Memorandum

To: Bryan Baker and Steven Kleppin; City of Norwalk
From: Michael Beattie, PE, PTOE
Date: October 28, 2021
Re: 283 Richards Avenue: Proposed Sikh Religious Center – Site Application Review
cc: Marissa Tarallo, PE, PTOE; AKRF, Inc.

Figure 1 – Parking Lot Layout

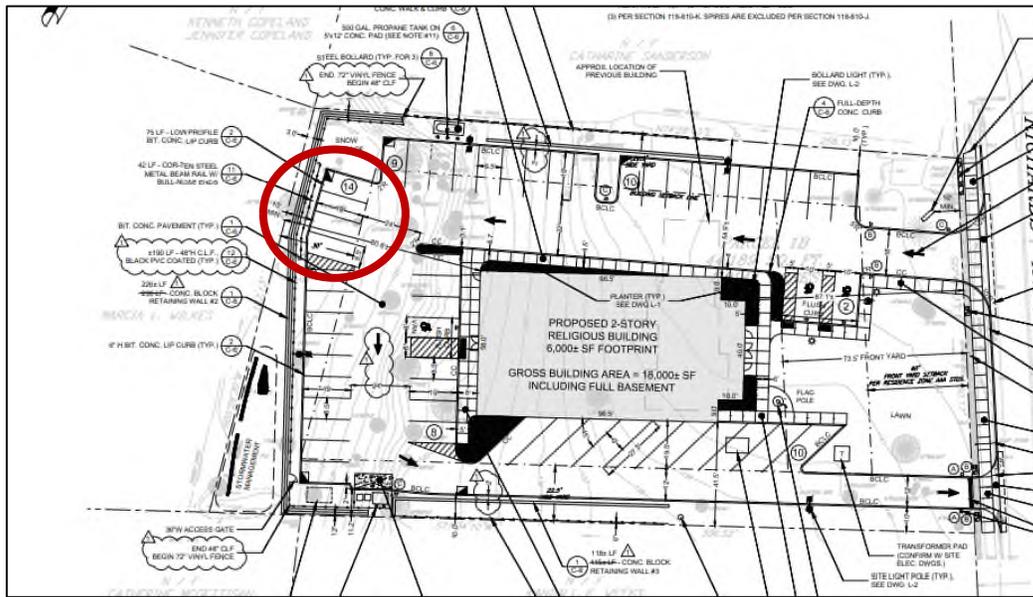
The northern driveway is a one-way enter only driveway while the southern driveway is a one-way exit driveway. With the proposed one-way circulation, there are four parking spaces that are slightly angled in the opposite direction of the one-way system (See highlighted area in **Figure 1**). The Applicant should conduct an AutoTurn analysis for these parking spaces to ensure a vehicle has adequate space to pull into and back out of the parking space.

1. Provide documentation or communication with CTDOT to verify the direction to not adjust 2021 counts and to apply a 0.6 percent the growth rate to develop future 2023 volumes.
2. Figure 8 – the northbound left at Richards Avenue/Fillow Street should be revised to show 45 vehicles.
3. The Applicant should clarify what the outbound trips during the arrival hour and inbound trips during the departure hour represent.
4. The Applicant should confirm the 240 seats are fixed to ensure the one space per 5 seats parking rate is appropriate.
5. The Applicant should respond to the parking supply provided versus the number of vehicles that appear to park on site based on the trip generation estimates.
6. The Applicant should conduct an AutoTurn analysis at the highlighted parking spaces to ensure a vehicle has adequate space to pull into and back out of the parking space.
